UNITED STATES PATENT AND TRADEMARK OFFICE

10/786,733

Office Action Summary	Application No. 10/786,733	Applicant(s) DIGGLE ET AL.	
	Examiner HADI SHAKERI	Art Unit 3727

DETAILED ACTION

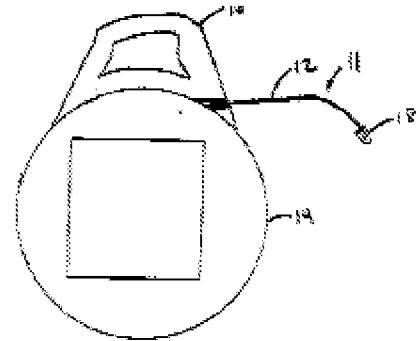
1. The drawings are objected to under 37 CFR 1.83(a). The drawings must show every feature of the invention specified in the claims. Therefore, the “semi-circular end wall blending to the wider bottom floor” as recited in claims 1, 11 and 19 must be shown or the feature(s) canceled from the claim(s). No new matter should be entered.

There is no support in the description for this. The Figure 5 and 5A drawings are so poor as originally filed that it is the examiner's position that these Figures do not provide support for this language. The bottom wall appears to be straight particularly when viewing Figure 5, however, there is no disclosure to support "a semi-circular" shape. Also, there no descriptions or drawings indicating as to how this semi-circular terminus blends into the wider bottom wall.

Corrected drawing sheets in compliance with 37 CFR 1.121(d) are required in reply to the Office action to avoid abandonment of the application. Any amended replacement drawing sheet should include all of the figures appearing on the immediate prior version of the sheet, even if only one figure is being amended. The figure or figure number of an amended drawing should not be labeled as “amended.” If a drawing figure is to be canceled, the appropriate figure must be removed from the replacement sheet, and where necessary, the remaining figures must be renumbered and appropriate changes made to the brief description of the several views of the drawings for consistency. Additional replacement sheets may be necessary to show the renumbering of the remaining figures. Each drawing sheet submitted after the filing date of an application must be labeled in the top margin as either “Replacement Sheet” or “New Sheet” pursuant to 37 CFR 1.121(d). If the changes are not accepted by the examiner, the applicant will be notified and informed of any required corrective action in the next Office action. The objection to the drawings will not be held in abeyance.

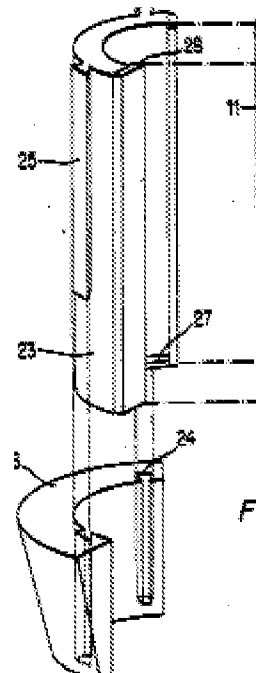
White shows a fish tape **22** that may be fabricated of a steel wire stored in a reel and provides slots or grooves to facilitate connection to wire or cable engaging attachments, meeting the claimed invention, except for particular size and dove-tail grooves.

Jansch teaches that an end of an elongate member may have a plurality of dovetail formations; e.g. See 25 in Figure 9 of Jansch. To provide on the end of the elongate member fish tape of White a plurality of dovetail formations would have been obvious in view of the Jansch disclosure. One skilled in the art would have been motivated to do this in order to facilitate a convenient and simple means for coupling the elongate fish tape to an object to be gripped by the fish tape. To provide dovetail grooves on the fish tape instead of formations would be no more than an obvious reversal of parts.

Further, whether the base of the groove semi-circular or slightly curved would be of immaterial difference and to make the base of the groove slightly curved would have been no more than an obvious matter of design choice absent a showing of criticality for this feature.
